INDESIT company

Model type:
AVD108SIT

Commercial code:
F029487

n1040325: New shock absorber fixing system with pin

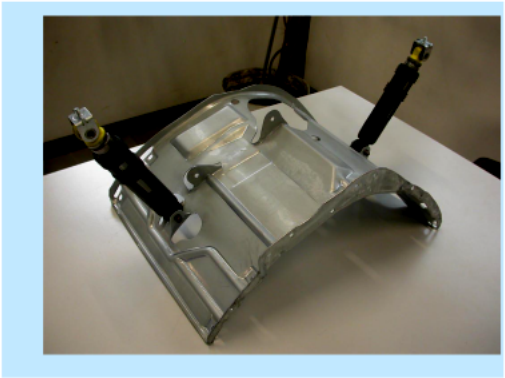
From serial no. 40427.0001, shock absorbers have been fixed to the tank unit cradle with two 11 mm pins code C00110163 (see fig. 01 and 02 enclosed) in place of the 8 mm screws code 093750 and relevant locking nuts code 030443, on all washing

machines and dryers produced in the Comunanza factory.
The items affected by this modification are:
1) The cradles have the same Service code, as they can be used in place of the new ones after widening the shock absorber fixing holes to a diameter of 10 mm.
Code 093848 - Tank unit cradle 46 lt
Code 093878 - Tank unit cradle 40 lt.
2) The new shock absorbers, with fixing bushing having no s/steel spacer, are not managed as they are interchangeable with the premodified items (make sure they are CIMA type, as the managed items), fixed with M8 screws code 093750 and related locking nut code 030443 (see figs. 05 and 06).
Code 093884 - Shock absorber 80 N
Code 093885 - Shock absorber 100 N

To remove the shock absorber from the tank, first extract the pin with a few hammer taps (see fig.03) until it is aligned with the tank bracket and then pull it out with a pair of pliers (see fig. 04).
(To refit the shock absorber use a new pin. Insert the pin until the toroidal edge is aligned with the bracket.)

Fig . 001

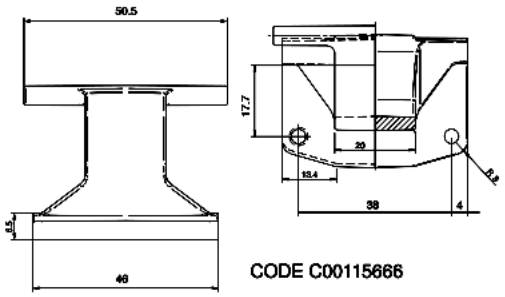
From serial no. 50207.0001, all Ariston models produced in the Comunanza factory (see table 001 attached) with industrial code (given on the rating plate) starting with 80, have been equipped with a Zamac hinge with 150° opening angle, code C00115666 (see Fig.001).
This modification has involved the introduction of the following items:

Code C00115668 - Complete door EVOII 150° silver with standard glass;
Code C00115673 - Complete door EVOII 150° silver snella standard glass;
Code C00115662 - EVOII body for 150° hinge white 27
Code C00115663 - EVOII body for 150° hinge silver 27
Code C00115664 - Snella EVOII body for 150° hinge white 27
Code C00115665 - Snella EVOII body for 150° hinge silver

The premodified items are not interchangeable separately with the modified ones.

Code C00096416 - Complete door EVOII LB 180° standard depth silver;
Code C00097374 - Complete door EVOII 180° WD 180° white 27 long glass;
Code C00110133 - Complete door EVOII Standard 180° white 27
Code C00110178 - Complete door EVOII Snella 180° Silver;
Code C00091836 - EVOII body white 27 for 180° hinge;
Code C00094306 - EVOII body silver for 180° hinge;
Code C00094305 - Snella EVOII body white 27 for 180° hinge;
Code C00094307 - Snella EVOII body silver for 180° hinge;

Fig . 001

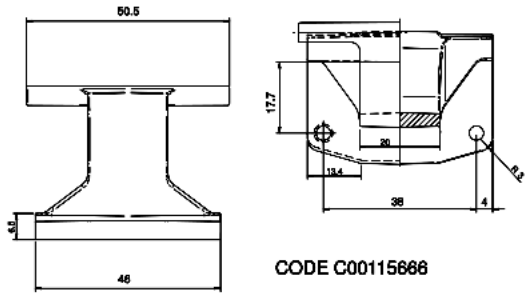
Beginning April 2008 spare parts warehouse started to manage the EVOII modules with eeprom fixed, these can only be programmed with smart card/palmare/pc.

Attention!! The premodification with eeprom socket can be programmed with smart card/palmare/pc using a blank eeprom or with pre programmed eeprom.

C00265676 with eeprom fixed - C00143068 with eeprom socket - for models with conducibility sensor
C00254298 with eeprom fixed - C00143068 with eeprom socket - for models without conducibility sensor
C00254297 with eeprom fixed - C00259941 with eeprom socket
C00254531 with eeprom fixed - C00143058 with eeprom socket
C00254297 with eeprom fixed - C00143057 with eeprom socket - for models without blocking drum
C00265697 with eeprom fixed - C00143057 with eeprom socket - for models with blocking drum
C00254297 with eeprom fixed - C00143056 with eeprom socket
C00254530 with eeprom fixed - C00259738 with eeprom socket
C00254533 with eeprom fixed - C00143060 with eeprom socket
C00254535 with eeprom fixed - C00145013 with eeprom socket
C00254530 with eeprom fixed - C00145551 with eeprom socket
C00254529 with eeprom fixed - C00142293 with eeprom socket
C00257406 with eeprom fixed - C00143989 with eeprom socket
